SERVICE BULLETIN

SUBJECT: AUTOPILOT CONTROL WHEEL DISENGAGE SWITCH

**MODELS
AFFECTED:** M20J S/N 24-0063, 24-0068, 24-0077, 24-0080,
24-0084, 24-0088, 24-0091 and 24-0093

FIGURE 1

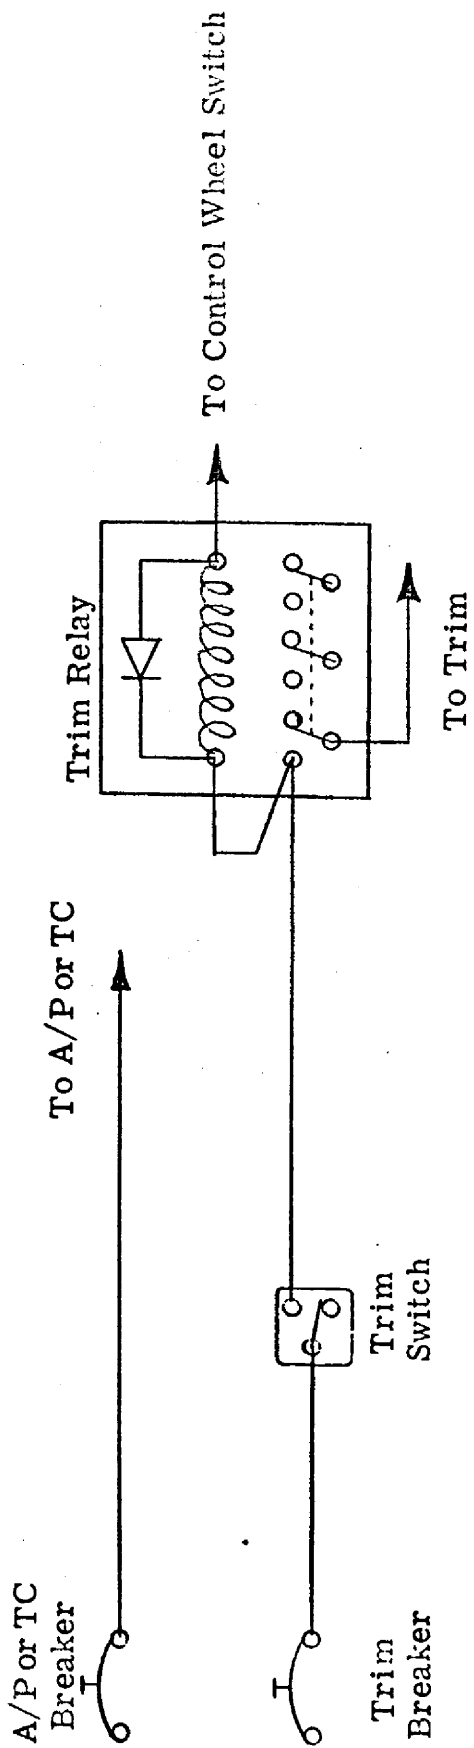
INTRODUCTION: In some instances, when an electrical elevator trim system has been installed, the control wheel disengage switch becomes inoperative if the "TRIM" circuit breaker is tripped. This can be corrected by a minor wiring change.

1. Disconnect the power lead from the disengage relay coil (located forward of right side of instrument panel on electrical junction plate). (See Figure 1 schematic).
2. Install diode assembly per Figure 2 schematic using window splices supplied.
3. Check operation of control wheel switch alternately pulling "Autopilot" (or Turn Coordinator if Brittain PC is installed) and "TRIM" circuit breakers. Control wheel switch should interrupt trim function when autopilot breaker is pulled and interrupt autopilot function when trim breaker is pulled.
4. Fill out enclosed compliance card and return.
